**ALASKA RAILROAD CORPORATION**  
327 W. Ship Creek Ave.  
Anchorage, AK 99501.

**Addendum 1**

ITB # 16-25-205011

ARRC 2016 Vehicle Purchase

### **Attachments Standards - Headache rack, ladder rack, and hood rack**

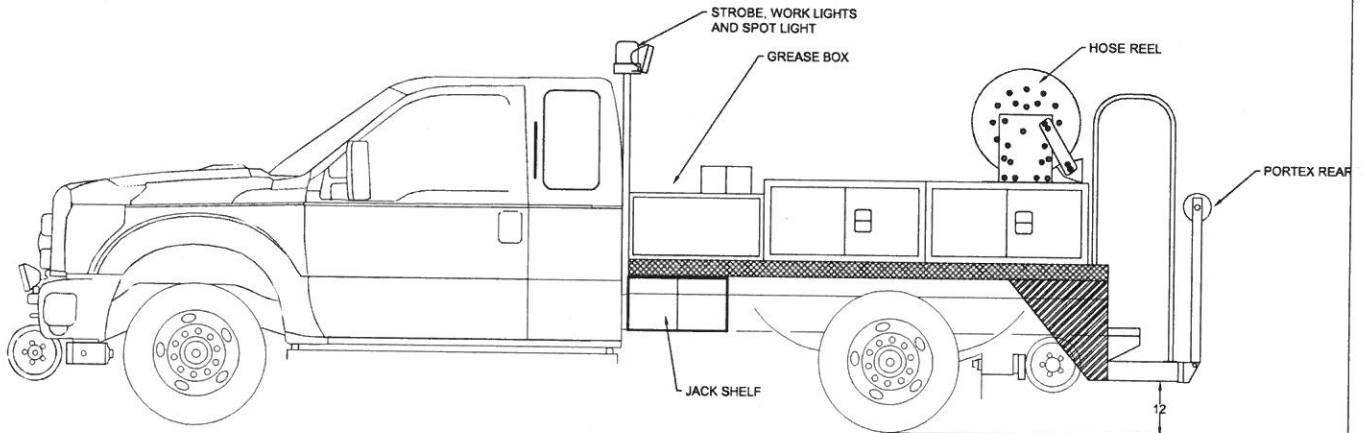
21. Do we have a min spec for capacity on the utility rack?
  - a. **1,000 lbs. minimum – See SOP on lighting, reflectorization, and attachments**
22. Vehicle # 1430: code 3 light bar what colors do we want; amber & white?

Truck bed ladder rack – 1,000 lbs. minimum weight capacity required

# V# 1431, TRACK INSPECTOR TRUCK

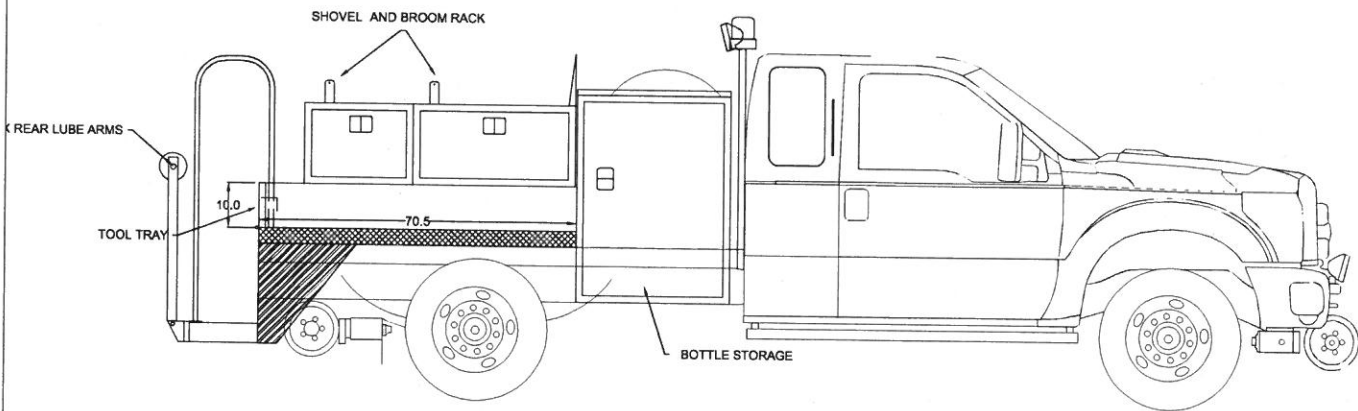
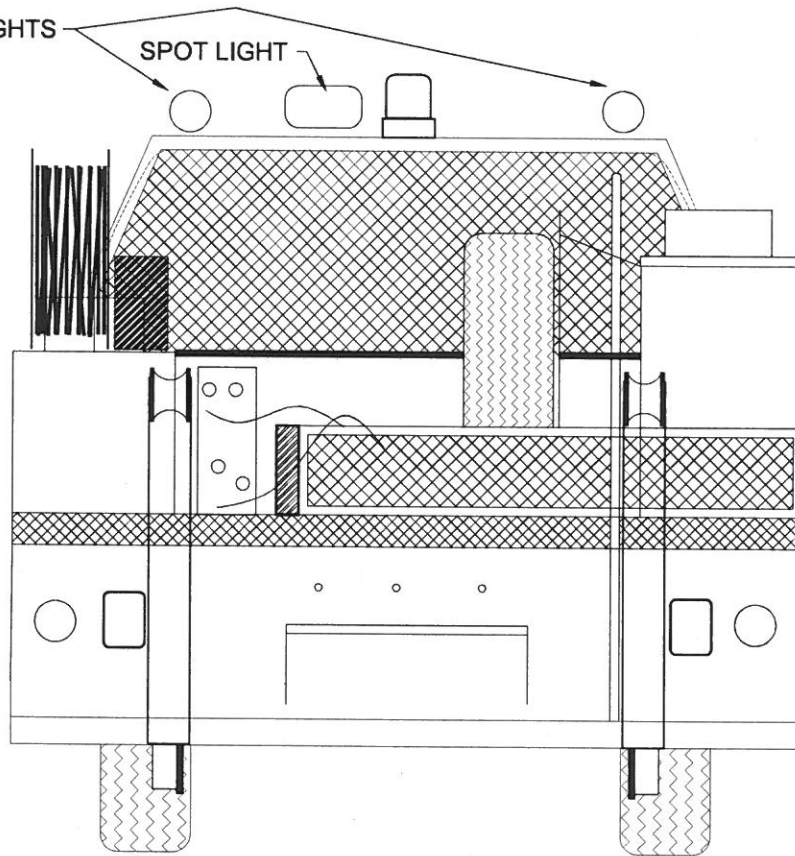
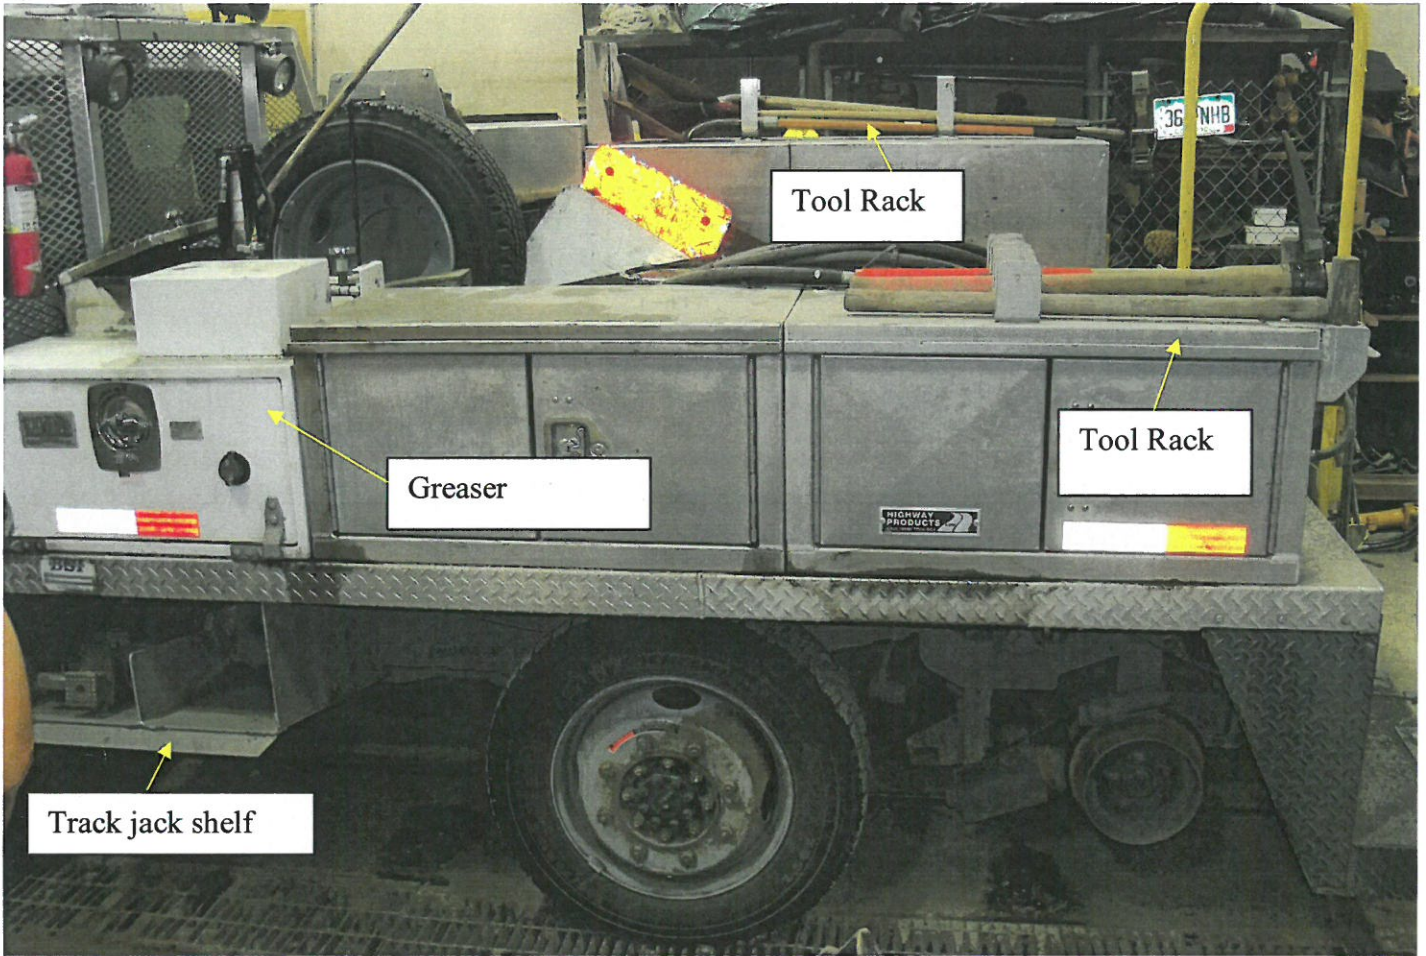
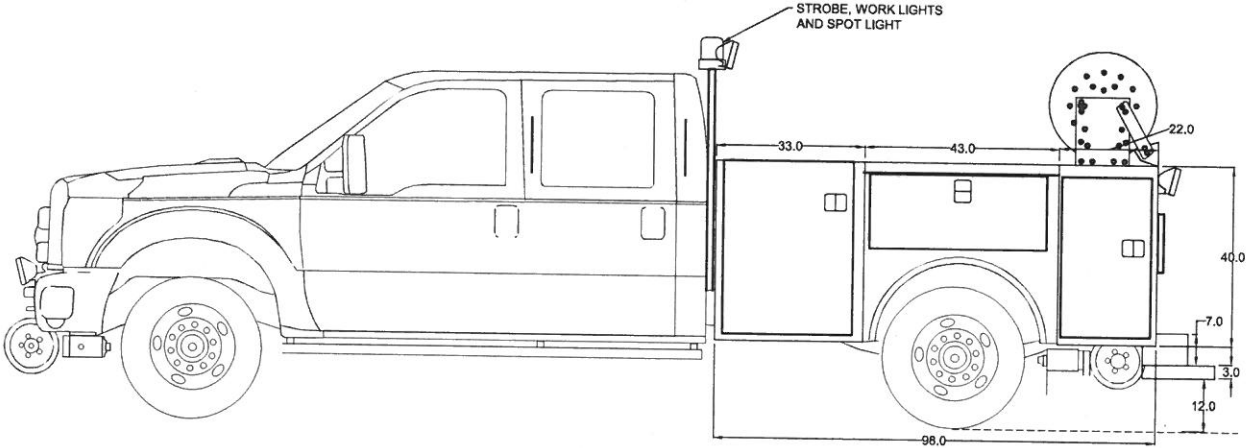
2. 13,000 GVW truck needs to be a dully to meet requirements
  - a. **No, super single tires meet 13,000 GVWR standards. See attached Track Inspector Truck drawing.**

58. Vehicle # 1431: Can you provide an example of the dual track jack holder below the deck behind the cab drivers side?

- a. **See attached Track Inspector truck configuration and diagrams**

V# 1438 SECTION TRUCK

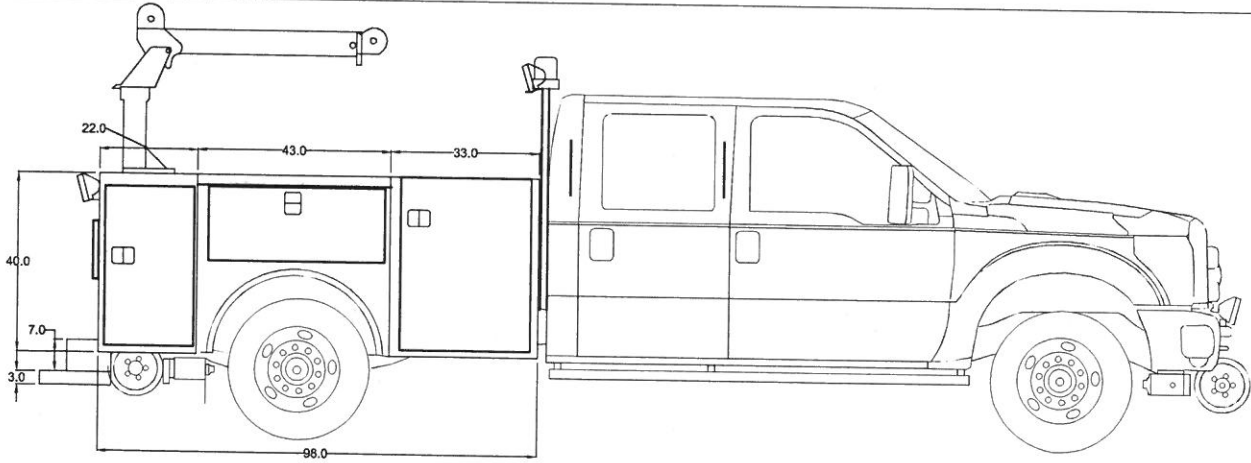
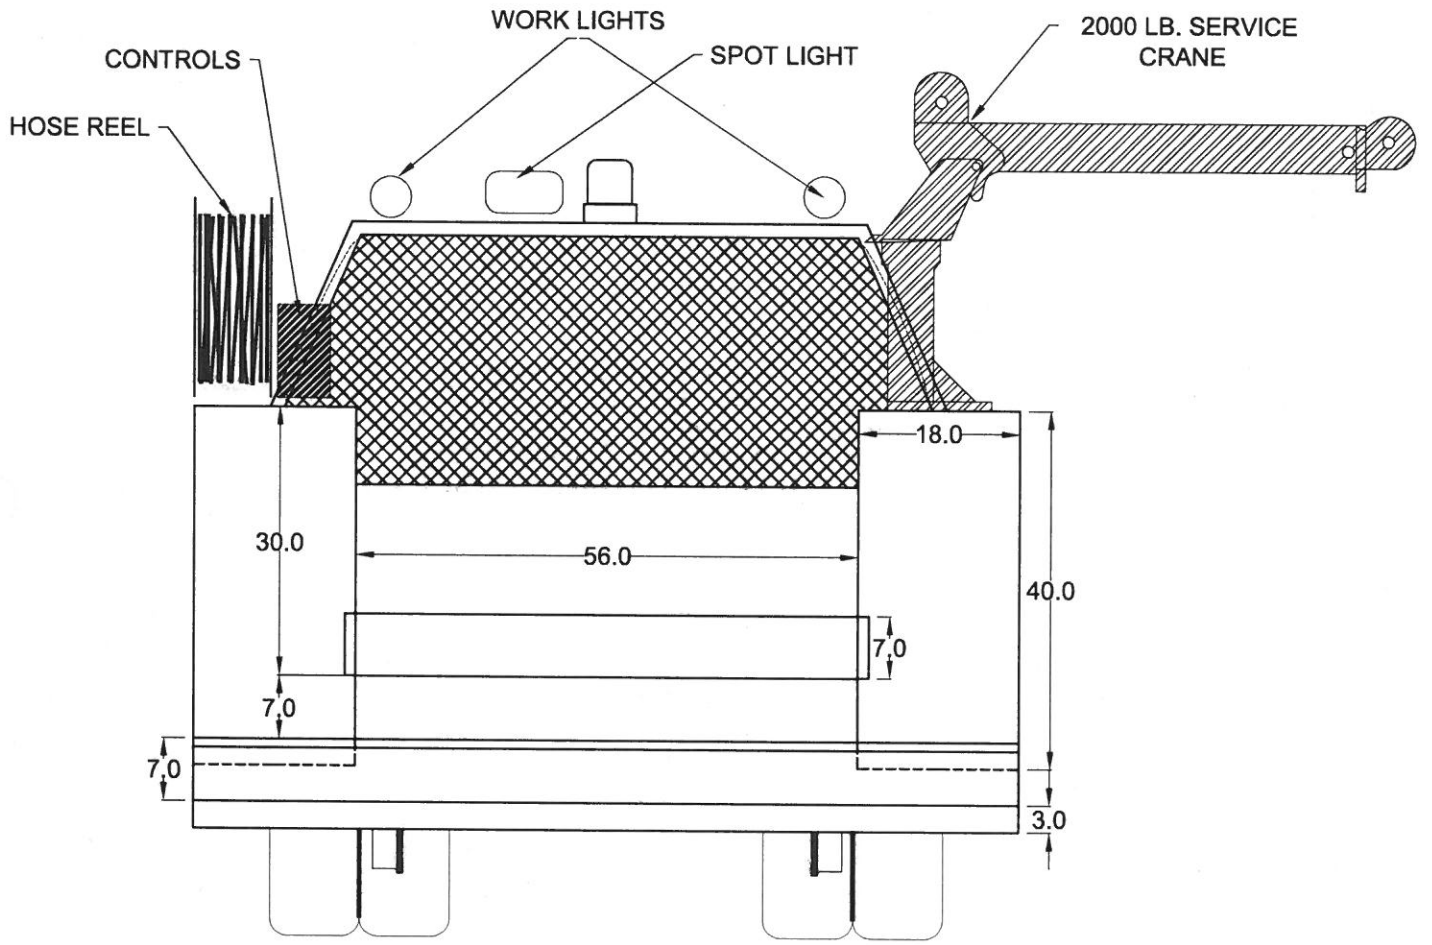
54. Vehicles # 1437 & 1438: Customer rear pumper what is the measurement for the required height from the ground?

- a. **Minimum 12" from ground level – see attached Section truck example**
